Project Name : Land West of Kingfisher Grove, Three Mile Cross

Job No : 23-117

Note Title : Estates Roads and Access Specification - Addendum 1

Wokingham Borough Council Comments

Refuse Vehicle

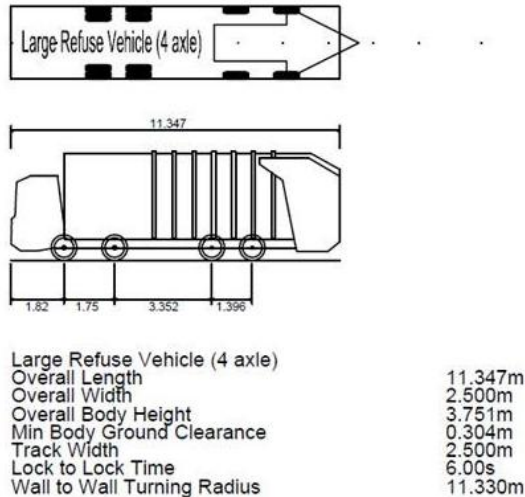
Paragraph 1.4.4 states that “Vehicle tracking confirms that a large refuse vehicle can enter and exit the site in forward gear”. This has not been provided. Vehicle tracking is to be submitted to show Refuse and Fire access into, circumnavigation of, and exit from site in the forward gear. The specifications for the design vehicles are provided below.

2.1.5 Please refer to tracking drawing ITB19902-GA-001 Rev.C which shows swept path analysis for the refuse vehicle. As fire appliance is smaller than the refuse vehicle it is deemed that fire appliance could track the scheme in a similar way by default.

Job Title LAND WEST OF KINGFISHER GROVE, THREE MILE CROSS		
Drawing Title GENERAL ARRANGEMENT OUTLINE CONDITION 07		
Client SOVEREIGN		
Scale 1:100 @A1	Date 16.10.25	Designed LG
Drawn LG	Checked BO	Approved BO
Job No 23-117	Drawing No 23-117-103	Rev B

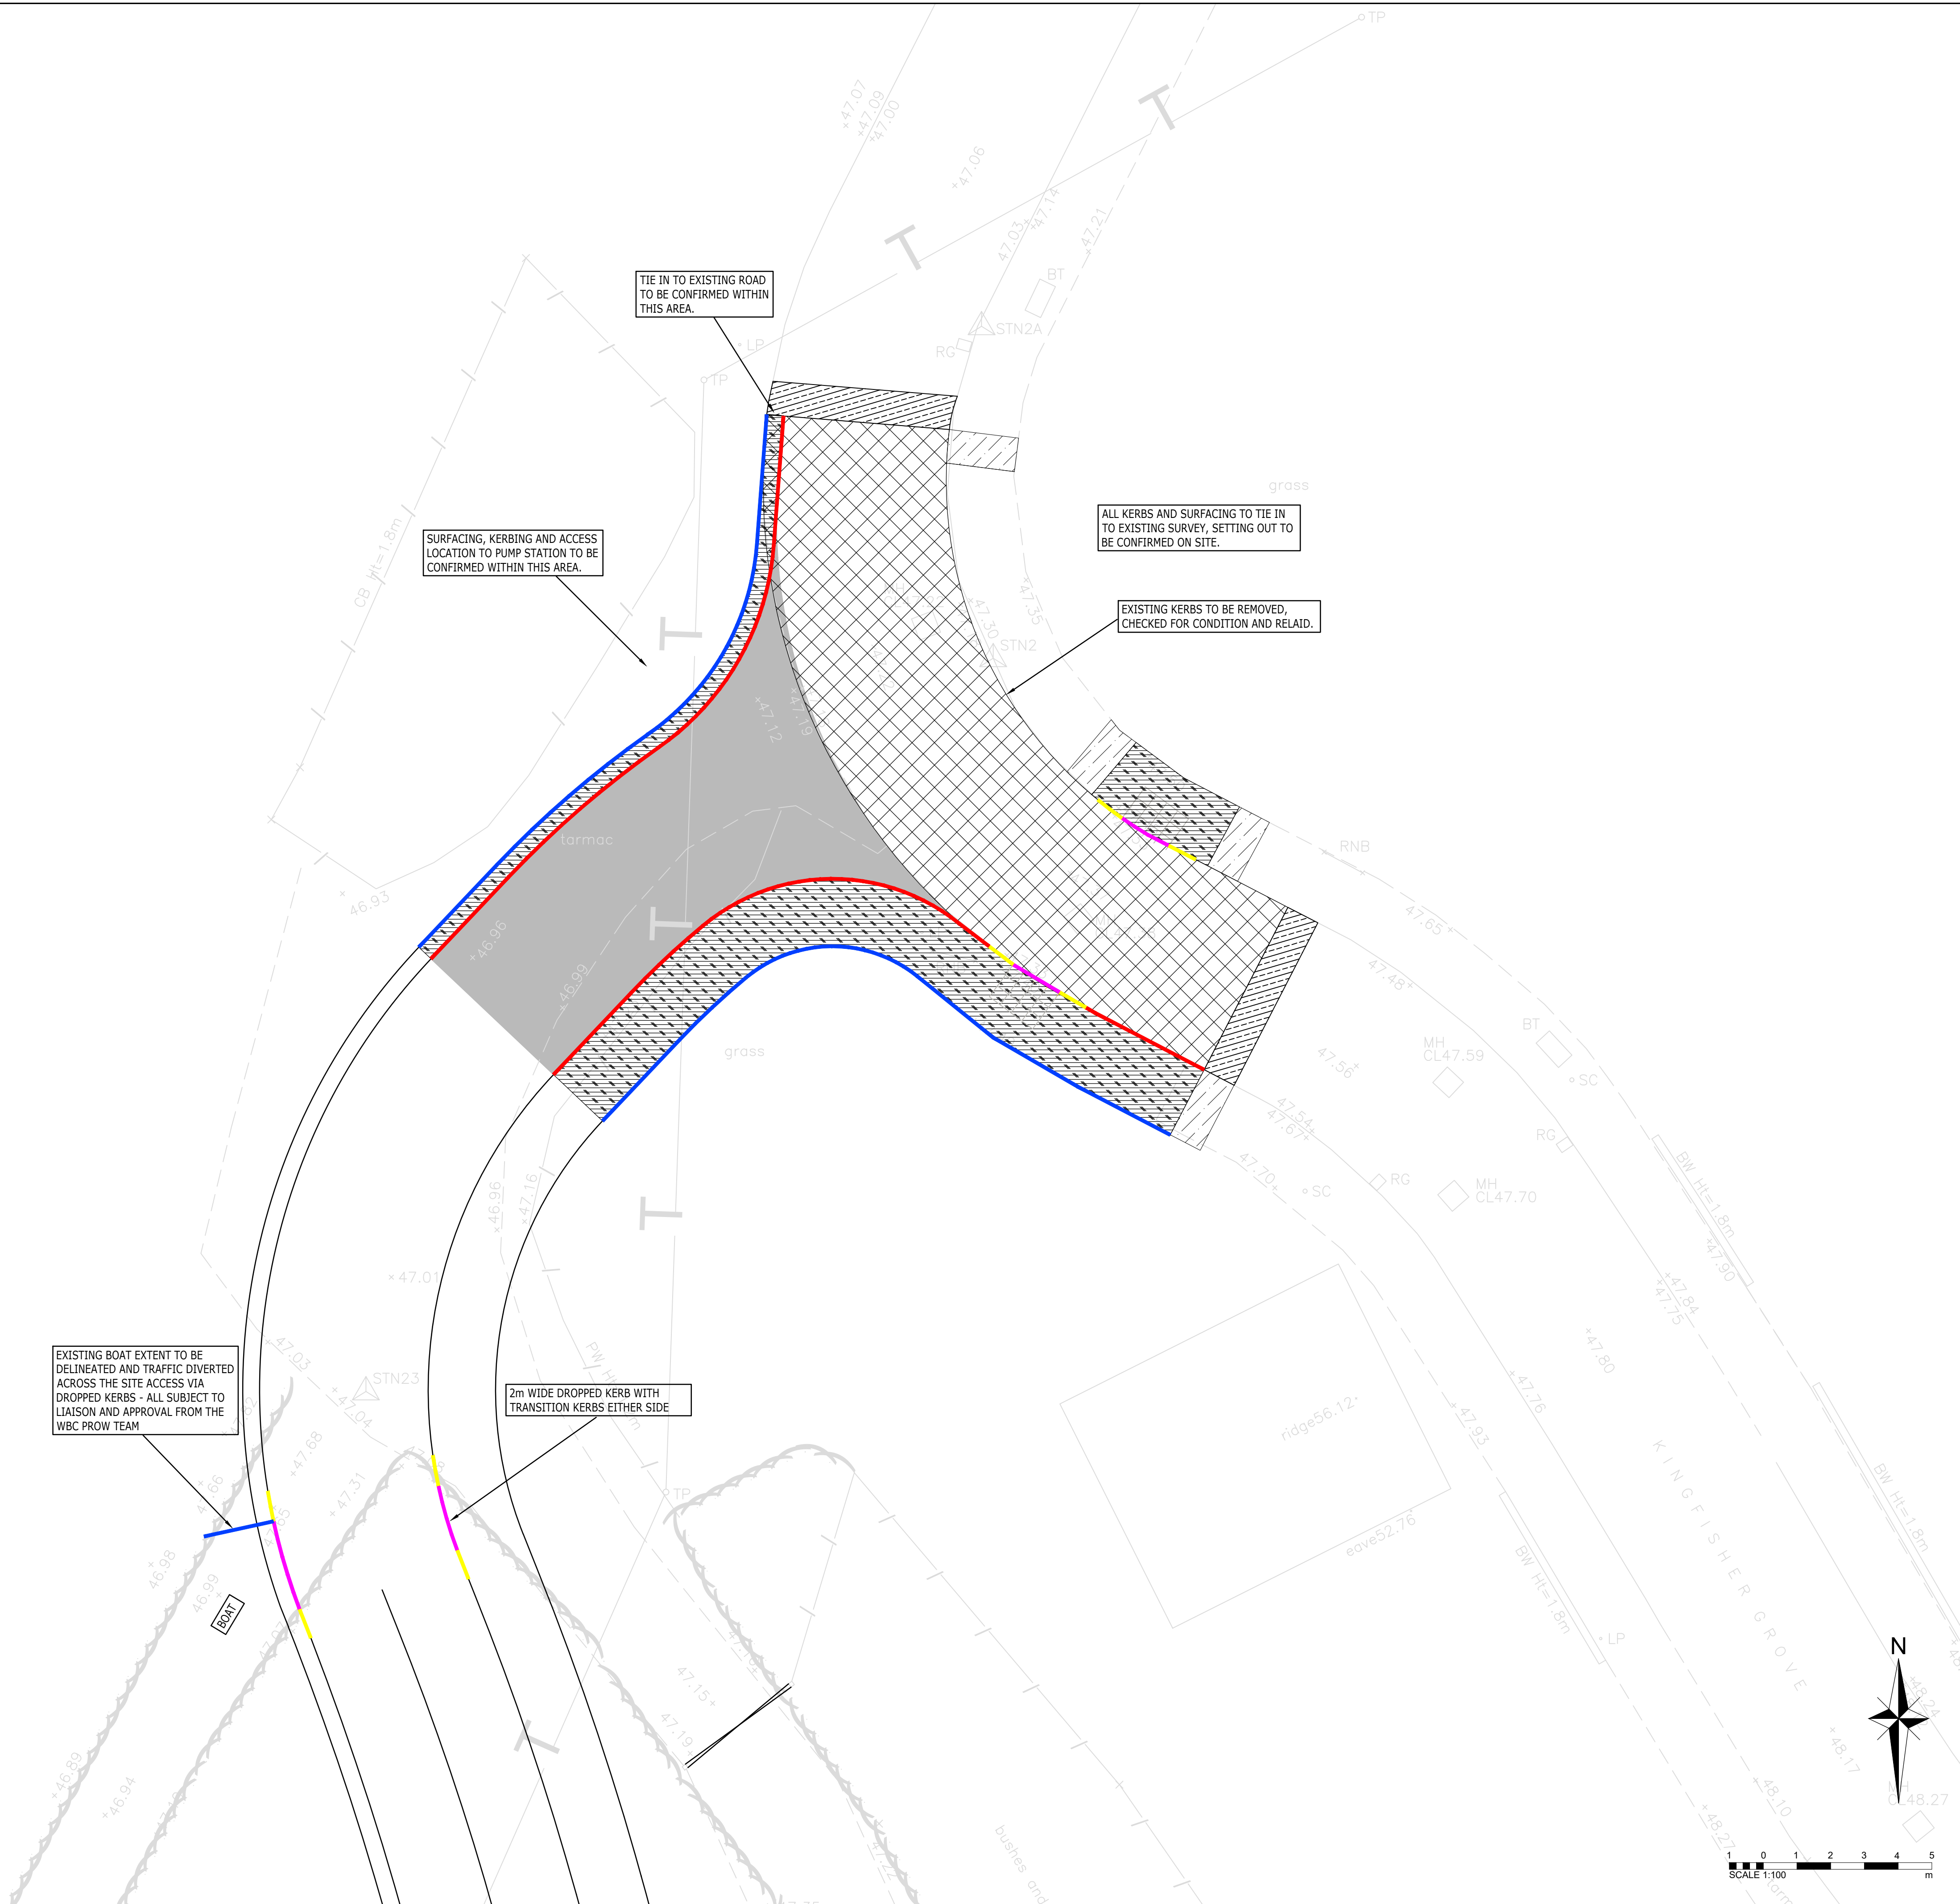
Drawing 23-117 23-117-103 A indicates 5.0m carriageway when Paragraph 1.4.2 states: The access ties into the existing highway with a 6.0m wide carriageway and 2.0m wide footways on both sides. Clarification as to the proposed carriageway width and how it complies with “WBC Living Streets 2019 – A Highway Design Guide for Wokingham” is requested

Paragraph 1.4.3 states “Visibility splays of 2.4m x 43m are provided in each direction and have been demonstrated to be achievable within the adopted highway or within the applicant’s control. Drawing 23-117 23-117-103 Rev A shows 2.4m x 25m visibility splays where the proposed access meets the existing Kingfisher Grove and 1.5m x 19m splays at the pedestrian crossing point. Clarification as to the proposed visibility splays and how they comply with “WBC Living Streets 2019 – A Highway Design Guide for Wokingham” is requested.

2.1.3 The width of the access at the junction was decided and agreed during the reserved matters planning stage and as such follows the approved drawing ITB15490-GA-002 Rev.E by i-Transport (condition 5 of the appeal states that development shall be carried out in accordance with the aforementioned plan).

2.1.4 The visibility splays for the scheme were decided and agreed during the planning stage and as such follows the approved drawing ITB15490-GA-002 Rev.E by i-Transport (condition 5 of the appeal states that development shall be carried out in accordance with the aforementioned plan). Please refer to the updated drawing 23-117-103 Rev.B which accords with the planning approved drawing ITB15490-GA-002 Rev.E.

B	VISIBILITY SPLAYS ADJUSTED TO ACCORD WITH A PLANNING APPROVED DRAWING ITB15490-GA-002 Rev.E		AK	GG	GG	17.02.26
A	DRAWING TITLE AMENDED		LG	BO	GG	21.11.25
Rev	Amendments		Drn	Chk	App	Date

Job Title		
LAND WEST OF KINGFISHER GROVE, THREE MILE CROSS		
Drawing Title		
SITE ACCESS CONSTRUCTION MAKEUP OUTLINE CONDITION 07		
Client		
SOVEREIGN		
Scale	Date	Designed
1:100 @A1	OCT 25	LG
Drawn	Checked	Approved
LG	BO	BO
Job No	Drawing No	Rev
23-117	23-117-104	B

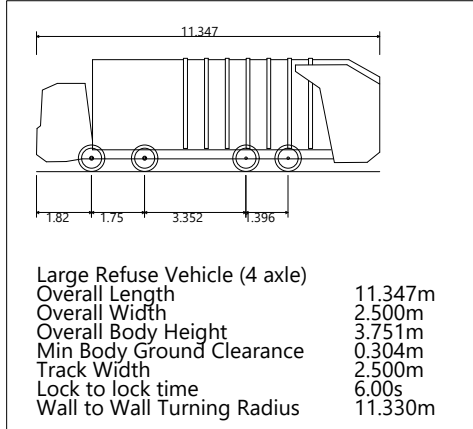
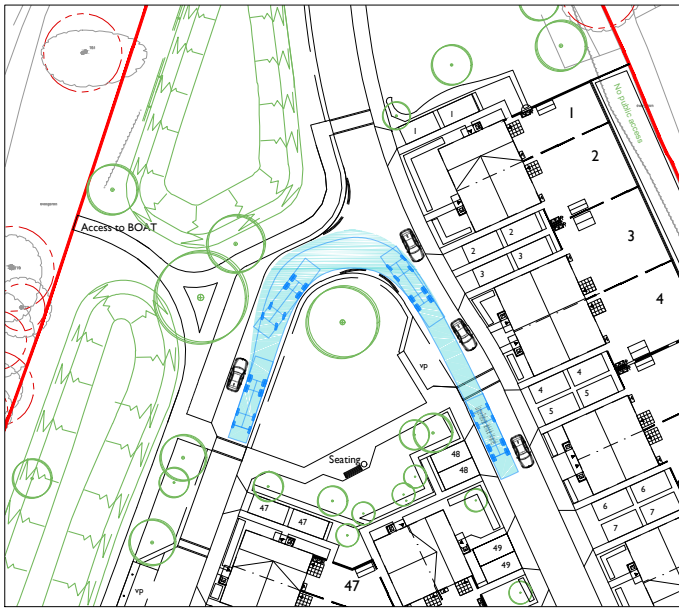
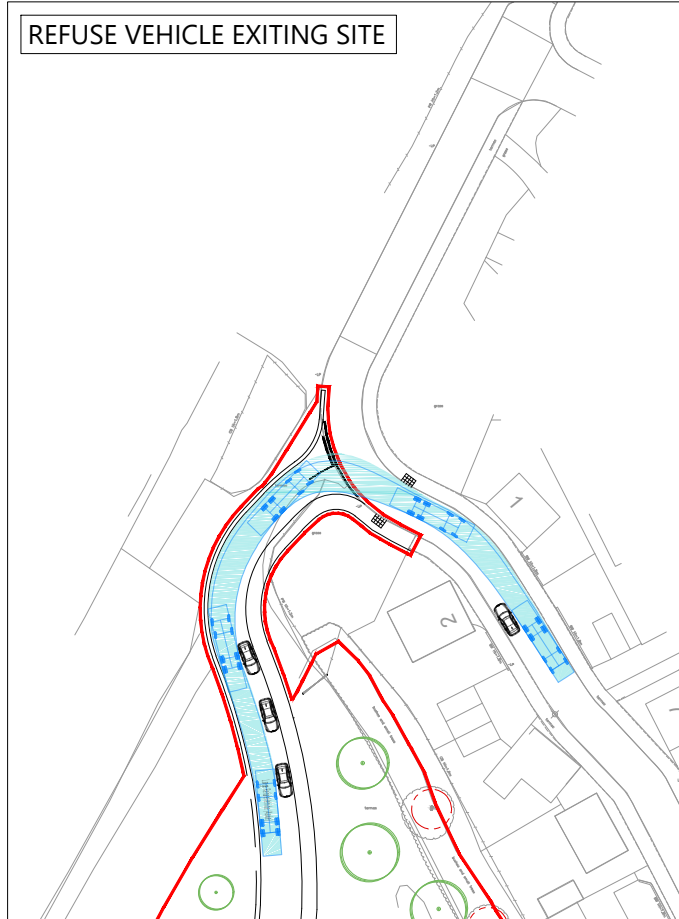
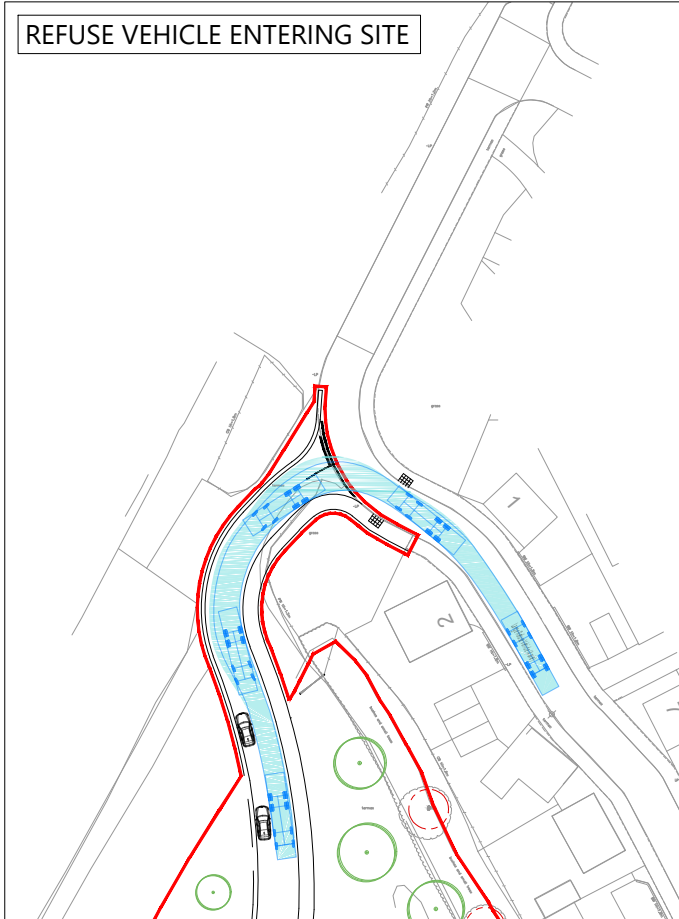
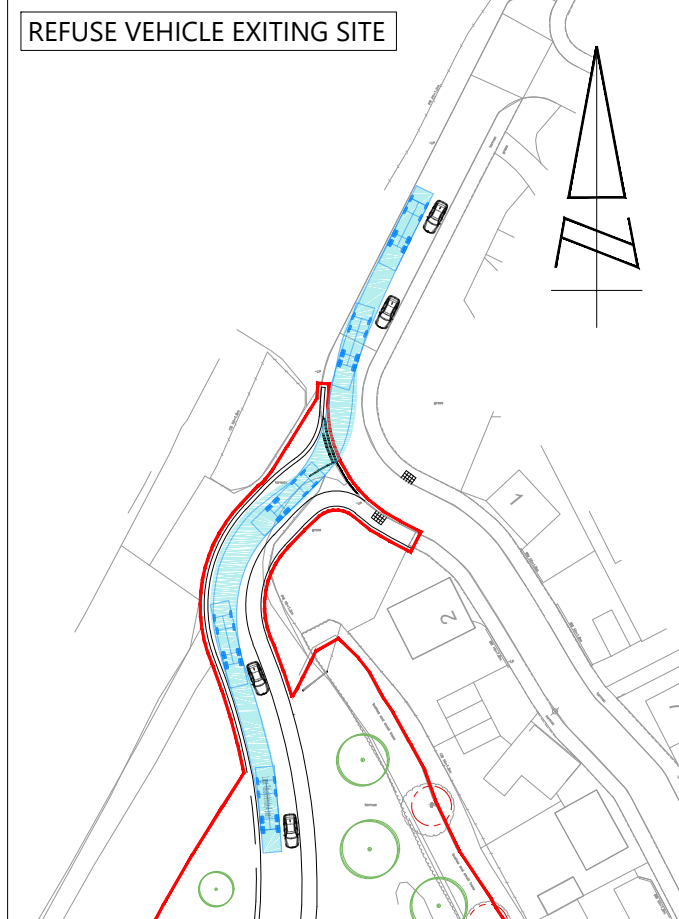
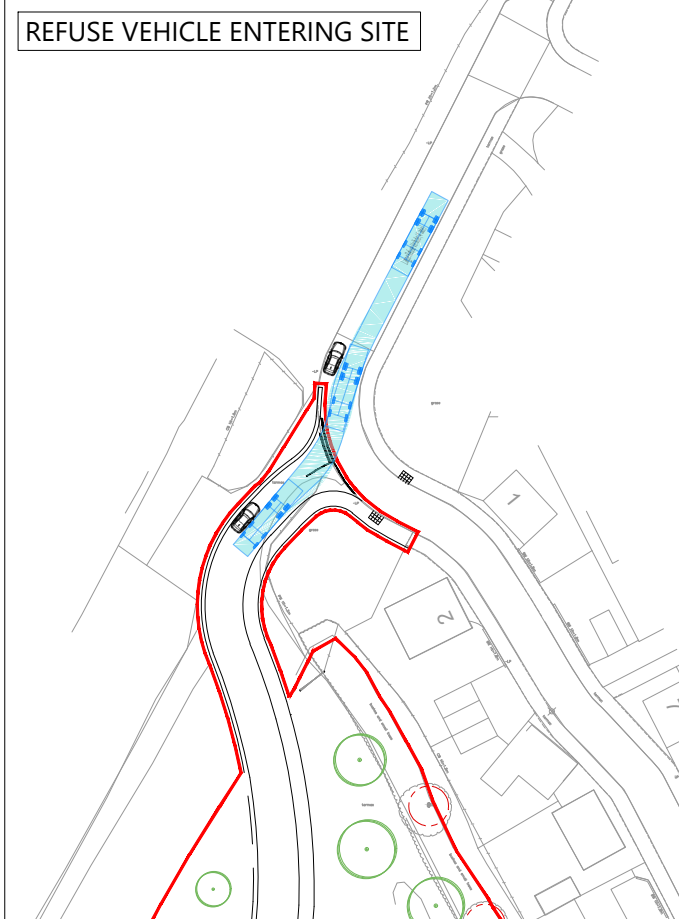
Details of the retained connection of the access to the public right of way (PROW) in the form of a Byway Open to All Traffic (B.O.A.T) where it meets the site access is to be provided (junction of site access and Kingfisher Grove). To enable all users to access the PROW, dropped kerbs are required both on the southern kerb line (where the PROW meets the carriageway and on the northern kerb line to provide a crossing point from the 2.0m footway. It is recommended that the applicant consult with the WBC PROW team regarding this.

2.1.7 Full proposals of the BOAT crossing and associated finishes would be subject to detailed design stage however initial proposals are indicated on drawing 23-117-104 Rev.B (subject to liaison and agreement from the WBC PROW team).

B	DROPPED KERBS INDICATED AT THE BOAT CROSSING	AK	GG	GG	17.02.26
A	DRAWING TITLE AMENDED	LG	BO	GG	21.11.25
Rev	Amendments	Dm	Chk	App	Date

Refuse Vehicle:

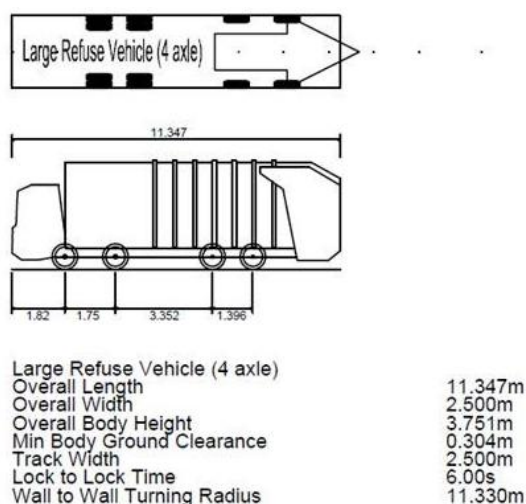
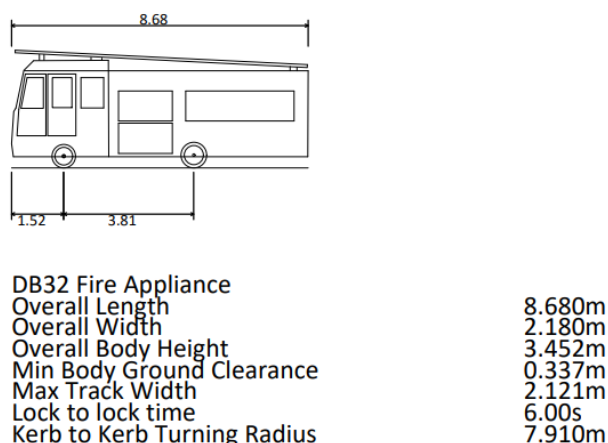
Paragraph 1.4.4 states that “Vehicle tracking confirms that a large refuse vehicle can enter and exit the site in forward gear”. This has not been provided. Vehicle tracking is to be submitted to show Refuse and Fire access into, circumnavigation of, and exit from site in the forward gear. The specifications for the design vehicles are provided below
